DESCRIPTIVE REPORT

Office No. FE-245

Locality Thirteen Miles South of

ATLANTIC MARINE CENTER
EVALUATION REPORT

FE-245
NORTH AMERICAN DATUM OF 1927
1:20,000 SCALE
APRIL-MAY, 1983
POLYCONIC PROJECTION

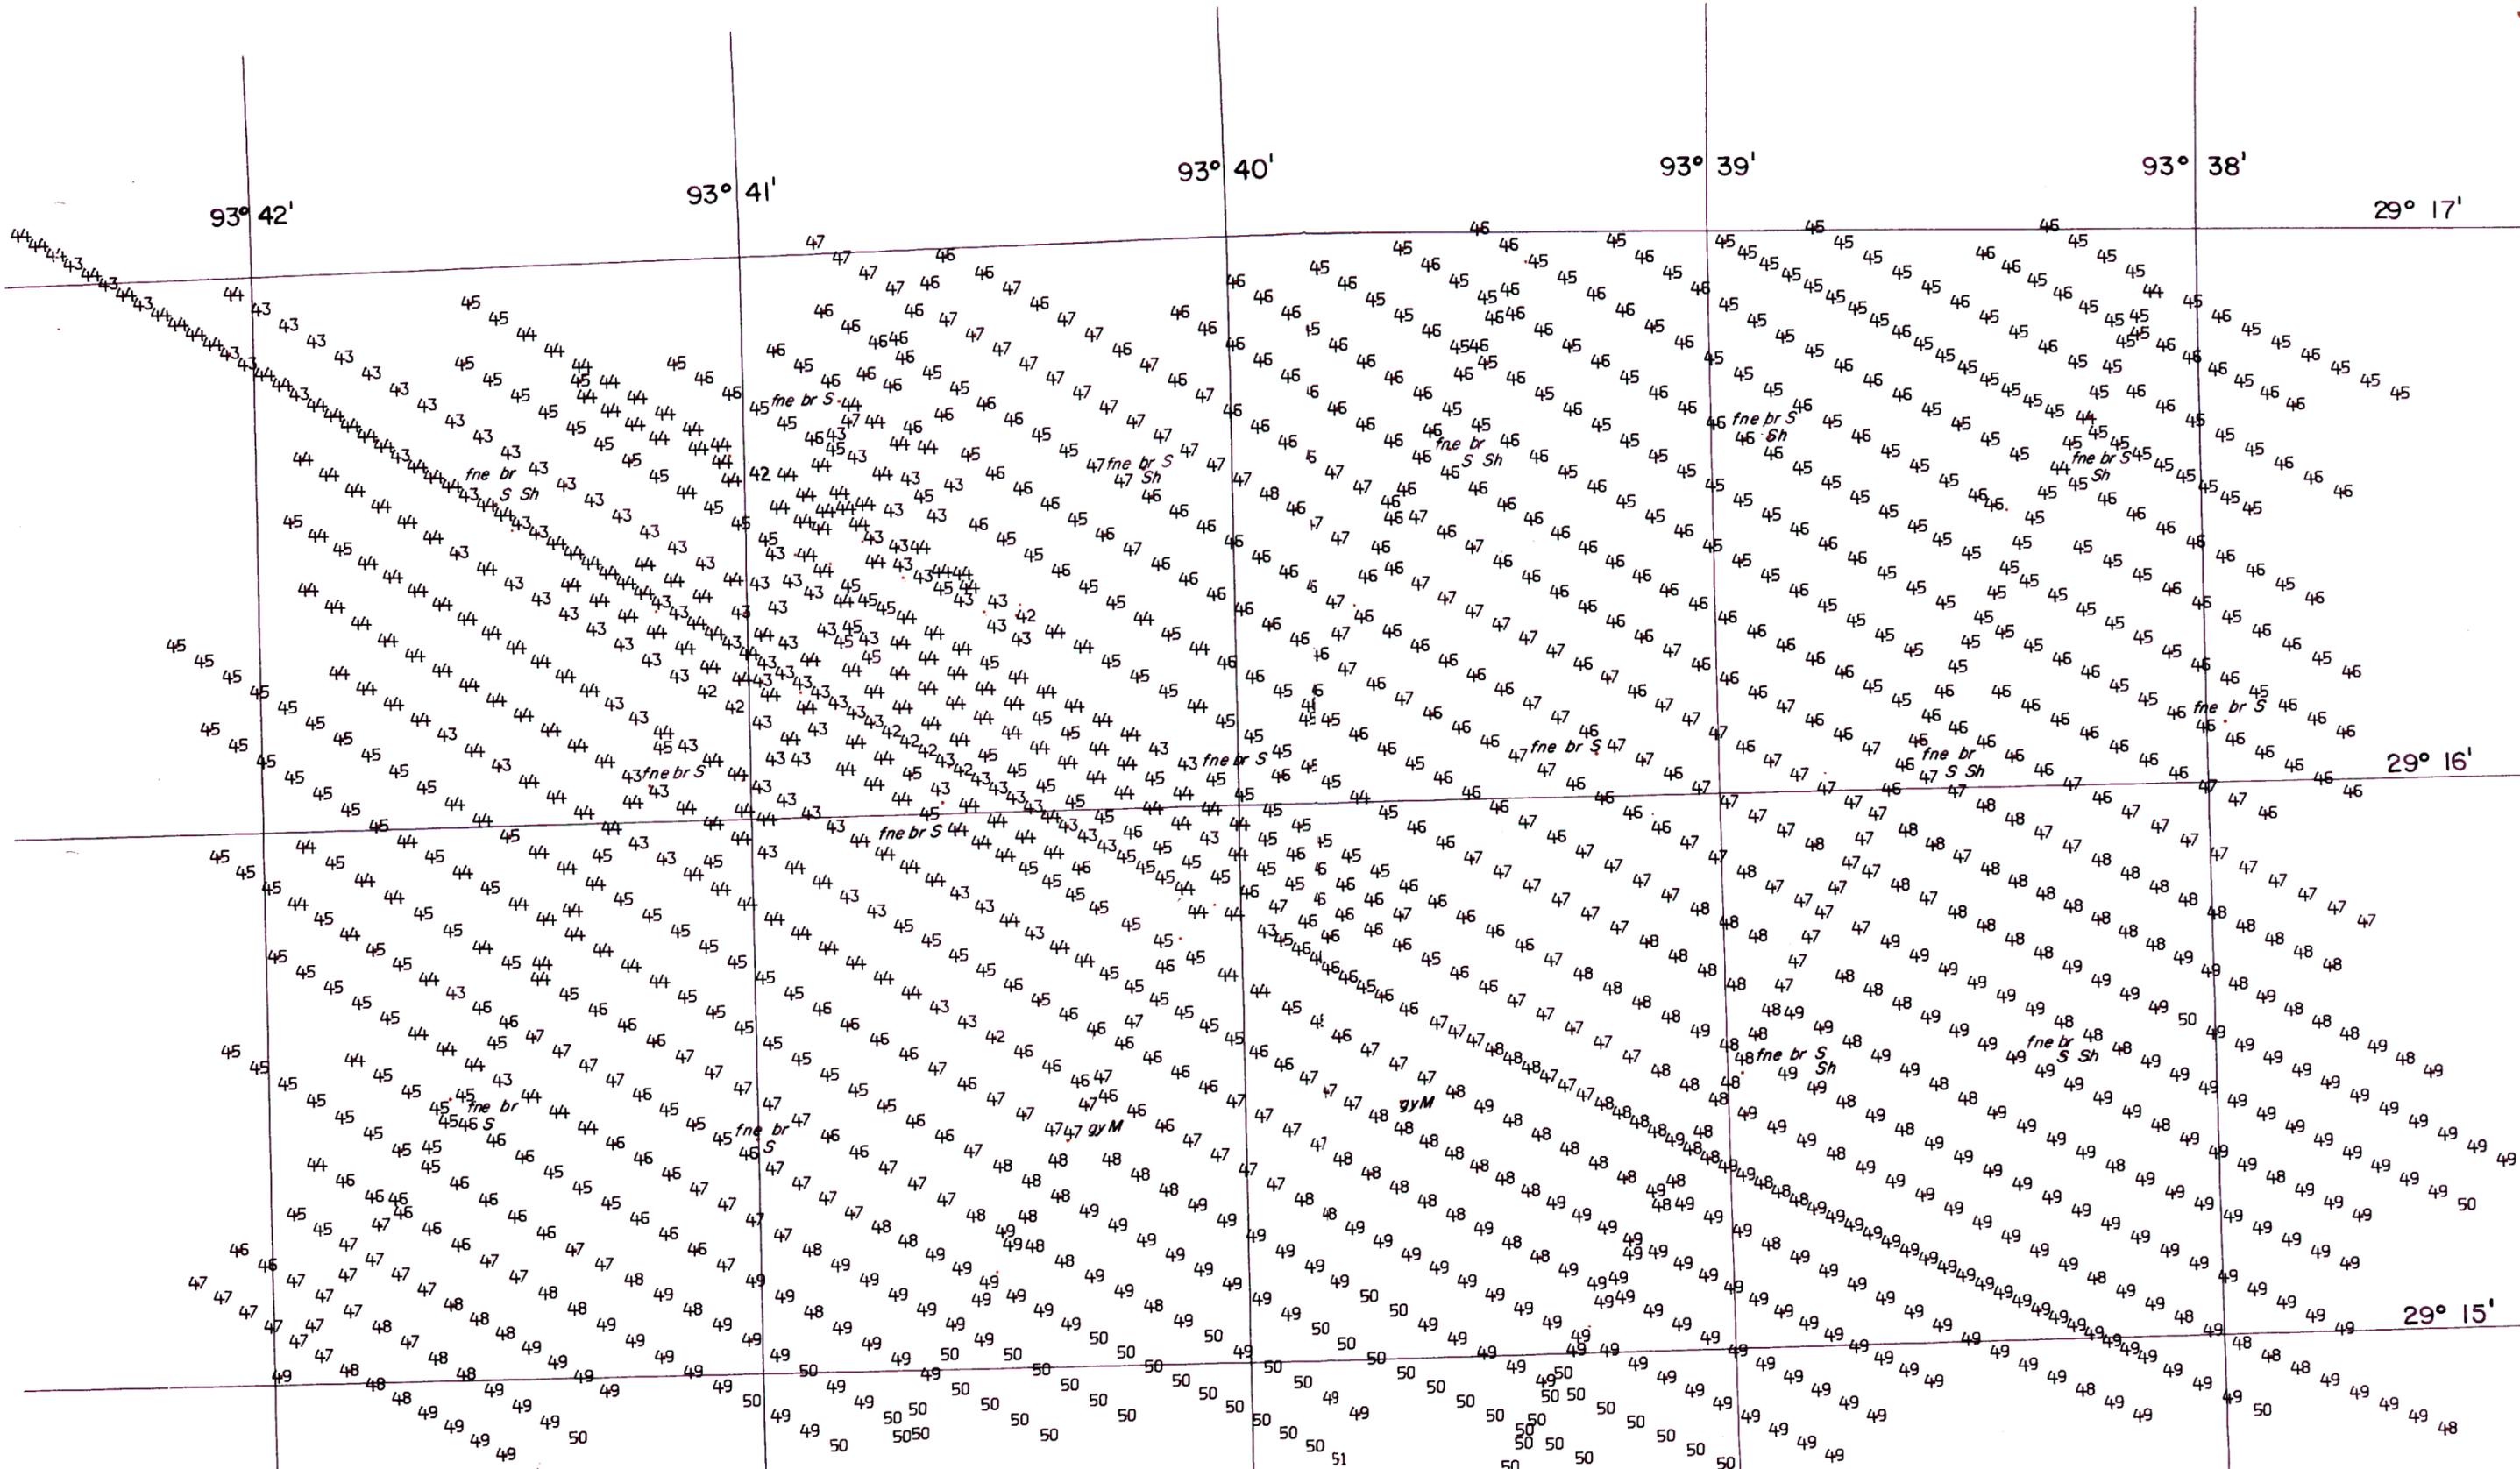
i. The one platform located by this field examination was not adequately described. Descriptions should include the size, orientation, and light and sound (horn, whistle, bell, etc.) characteristics. The hydrographer should have made contact with the U.S. Coast Guard, Eighth District, to gain any additional information that may be available about the platform.

j. The charted wreck of the GULF TIDE (Latitude 29°15'48", Longitude 93°39'25") was not investigated by this field examination. No sounding lines were run over the charted position. Side scan sonar was aboard and was used during this survey but not in the vicinity of the charted wreck. This wreck is not adequately addressed by the hydrographer. See section 6.b. of this report.

o. Bottom samples were not plotted on the final field sheet.
